## Product Change Notice (PCN)

PCN Number: **PCN-0455007R**

Product(s) Affected: *PJ-036AH-SMT-TR*

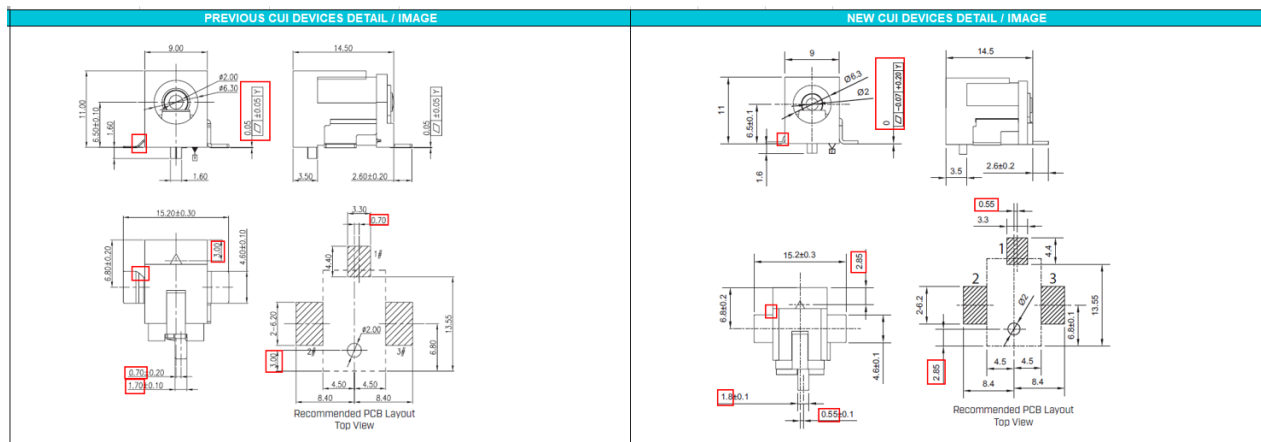
Description of Change: *Product re-engineered for improved manufacturability and production yield. Coplanarity specifications changed. Shape of terminal 2 changed. Location and size of terminal 1 changed. Locating post PCB hole location changed. See image below for reference and check CUI Devices website for updated drawing. Cosmetic differences may be visible and not affect the form fit and function of the product.*
